CLOVERLEAF SUBDIVISION
LOCATED IN NE1/4 OF SECTION 23 AND NW1/4 OF SECTION 24,
TOWNSHIP 11 SOUTH, RANGE 67 WEST OF THE 6TH P.M.,
COUNTY OF EL PASO, STATE OF COLORADO
ROADWAY PLANS

EPC STORMWATER REVIEW COMMENTS
IN ORANGE BOXES WITH BLACK TEXT

CLOVERLEAF FILING 2
EL PASO COUNTY, COLORADO
STORM SEWER AND POND PLANS

PUBLIC UTILTY PLAN

DP05 PROFILE
STA 1+00.00 TO 10+32.61

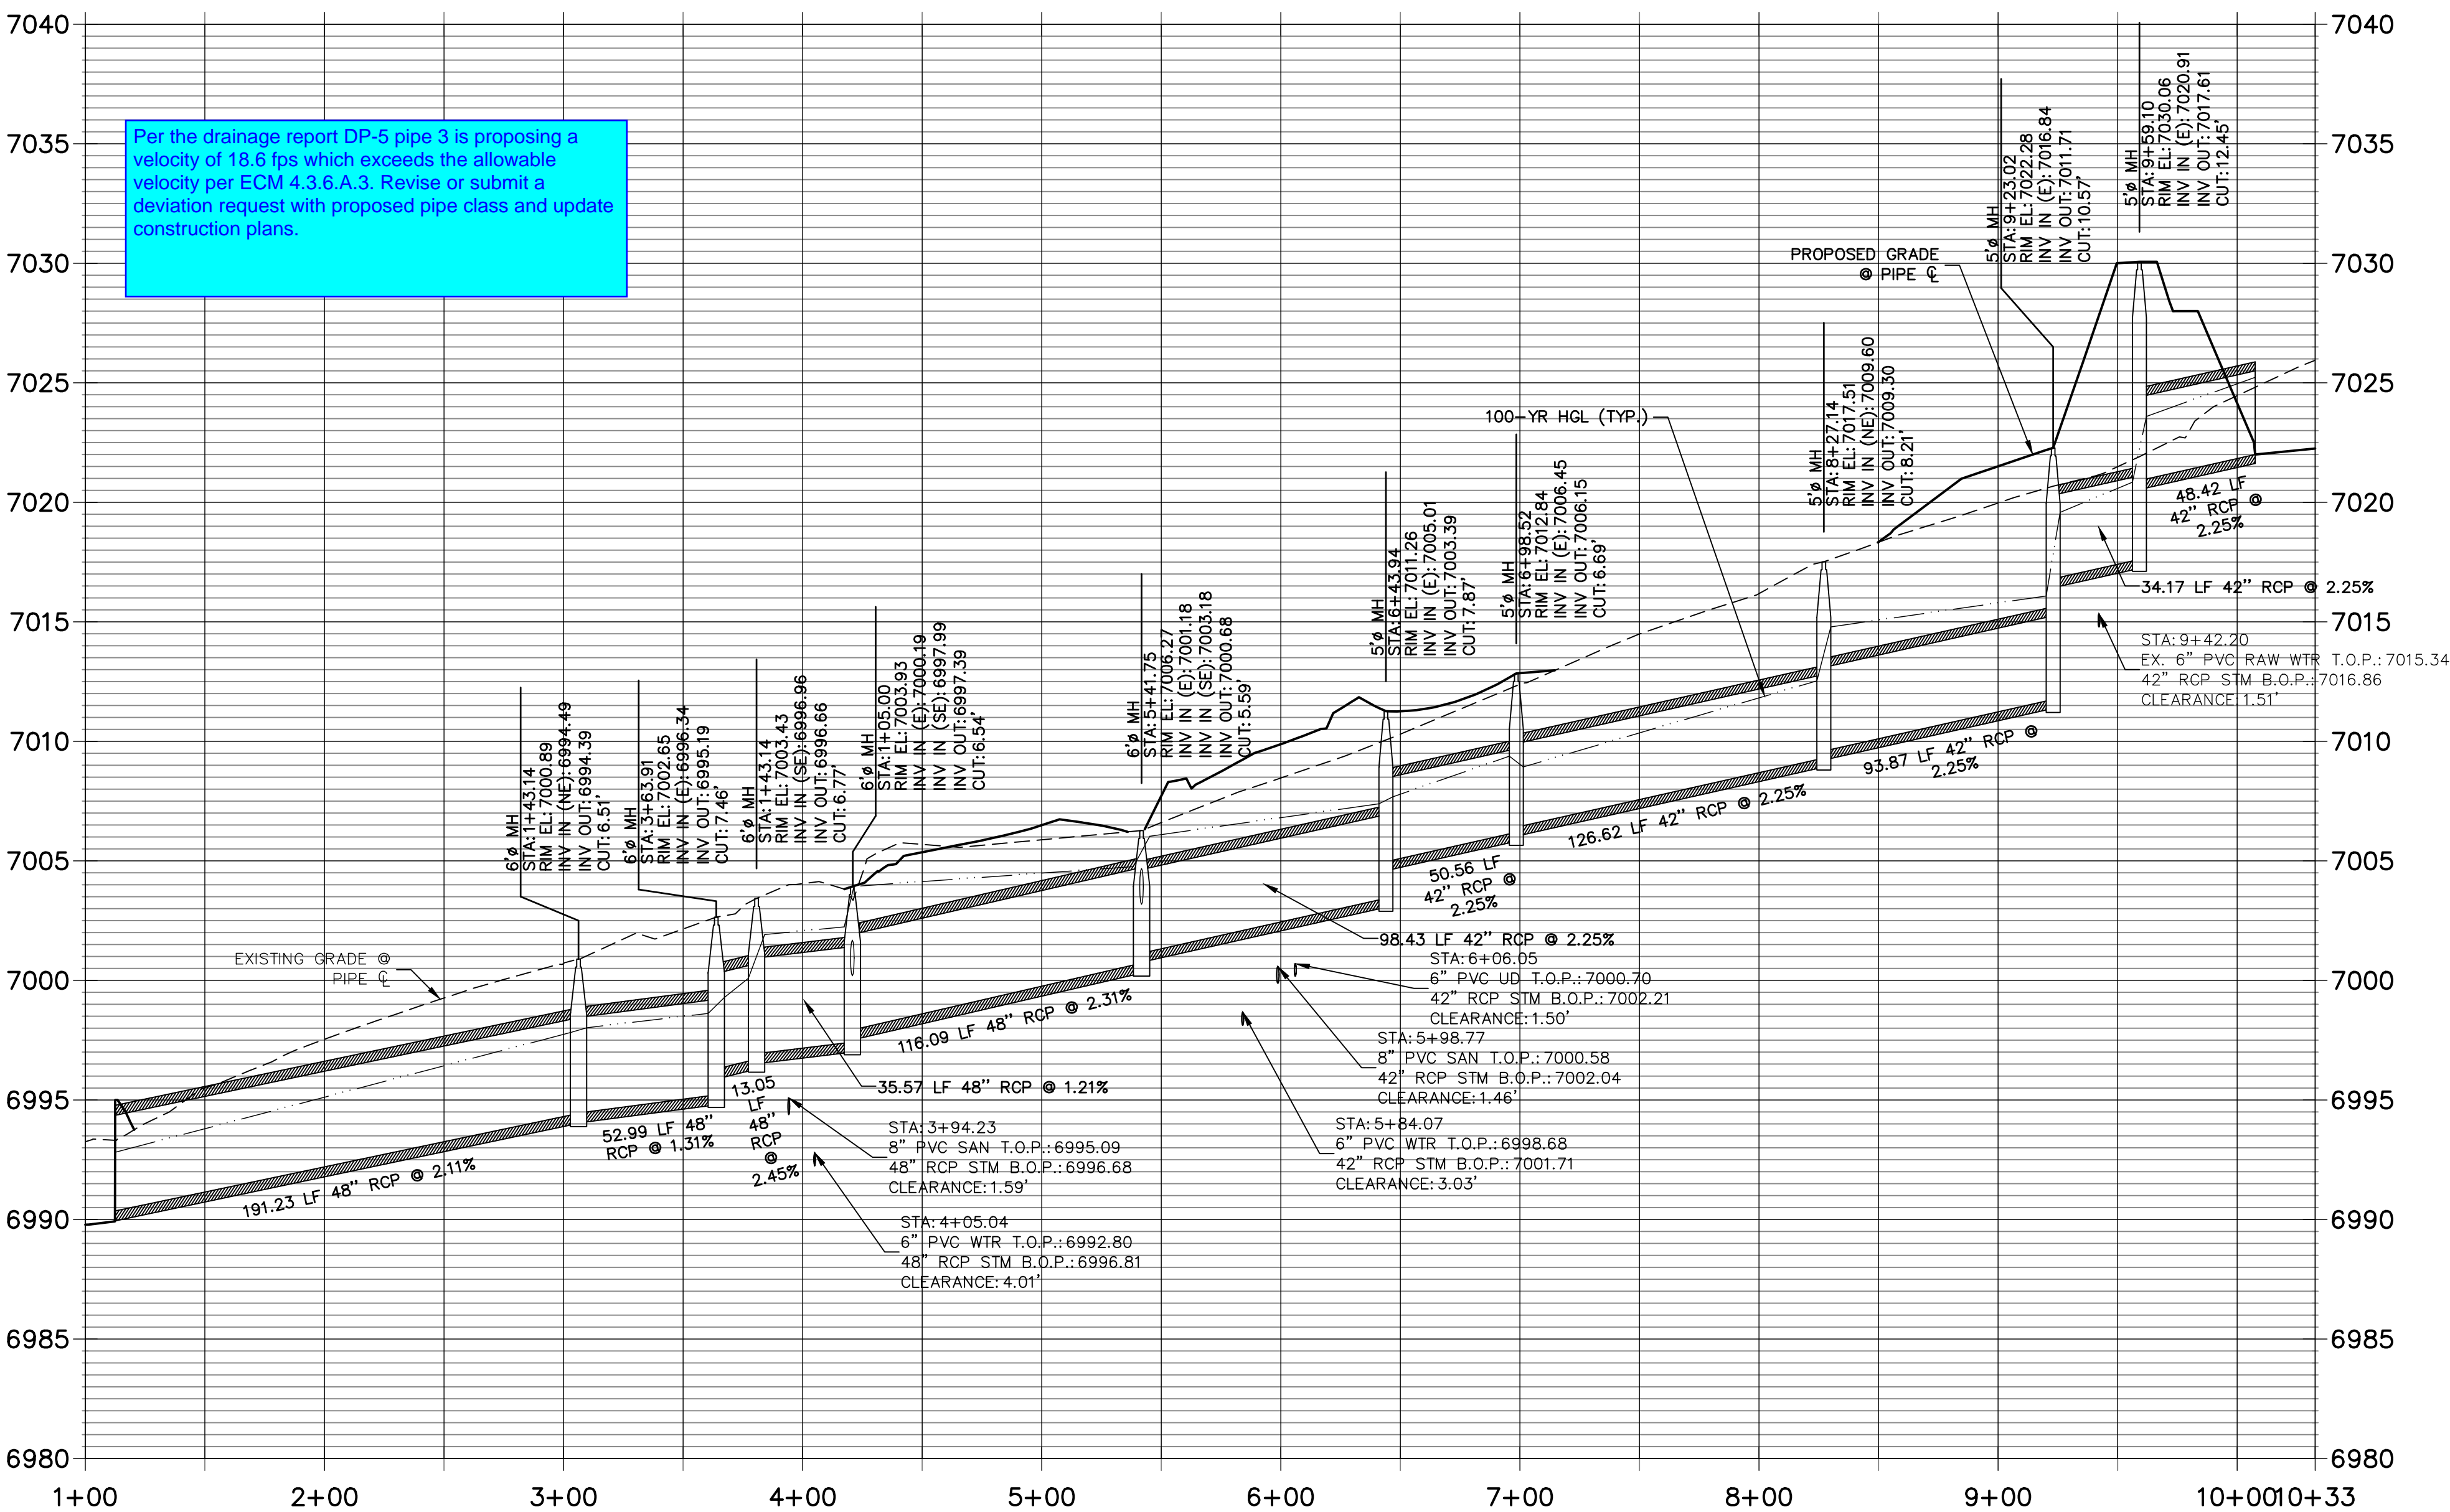
Per the drainage report DP-5 pipe 3 is proposing a velocity of 18.6 fps which exceeds the allowable velocity per ECM 4.3.6.A.3. Revise or submit a deviation request with proposed pipe class and update construction plans.

POND 1 PLAN

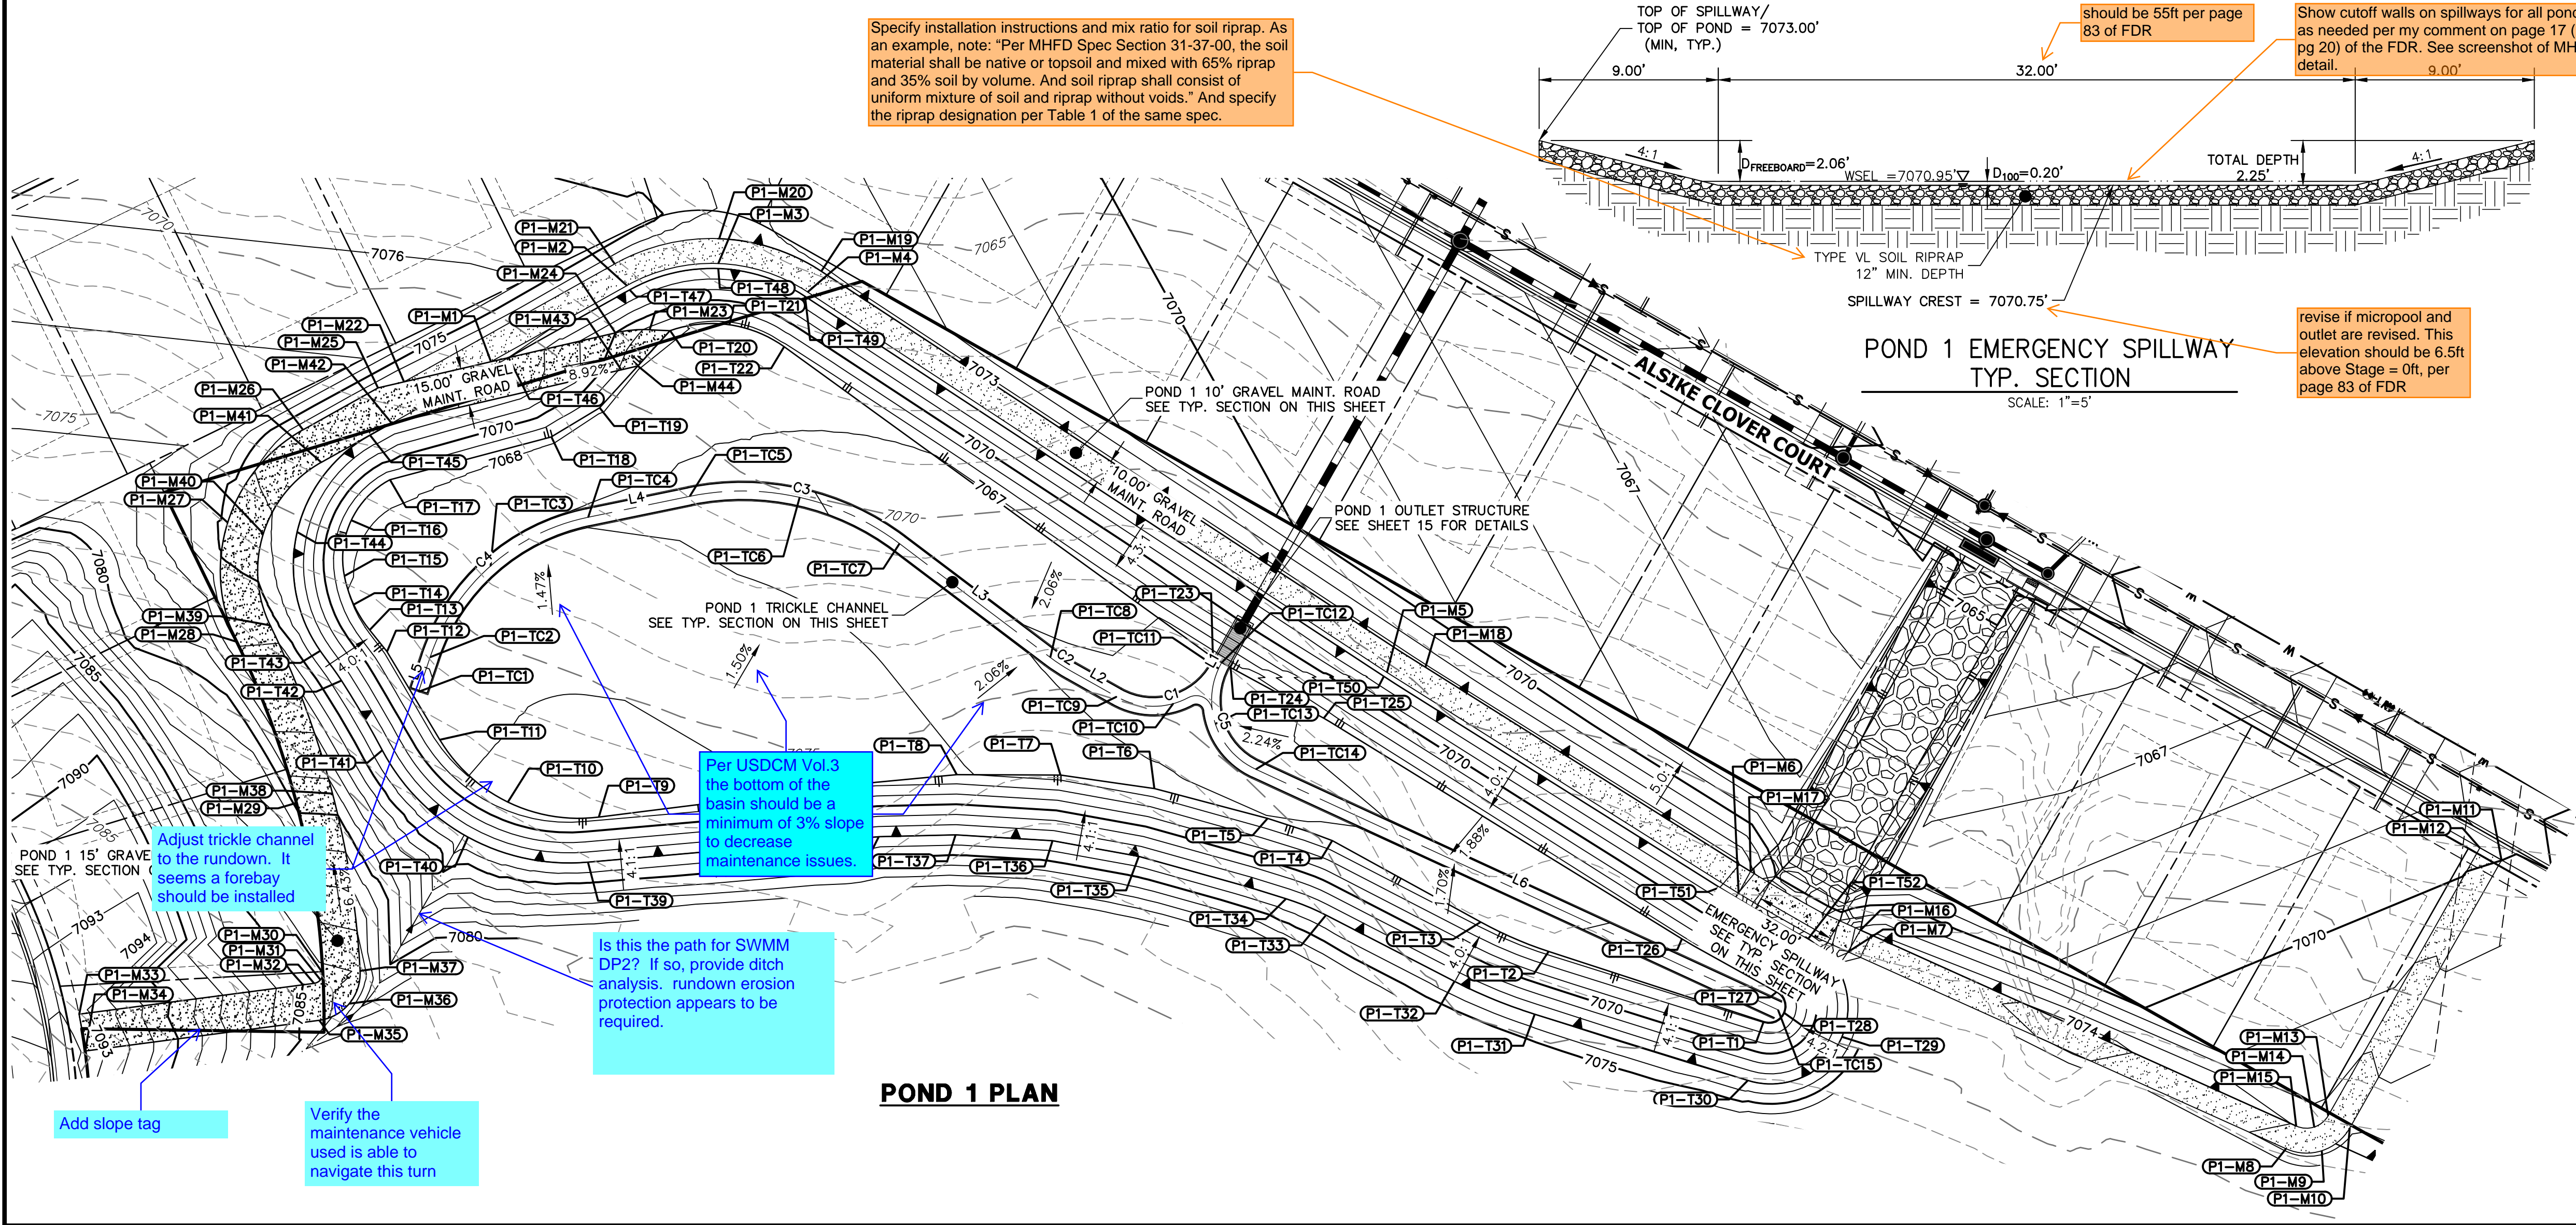
Show cutoff walls on spillways for all ponds as needed per my comment on page 17 (pdf pg 20) of the FDR. See screenshot of MHFD detail.

revise if micropool and outlet are revised. This elevation should be 6.5ft above Stage = 0ft, per page 83 of FDR

Per DCM 6.5.3 access roads should be a minimum of 15 feet. Revise.
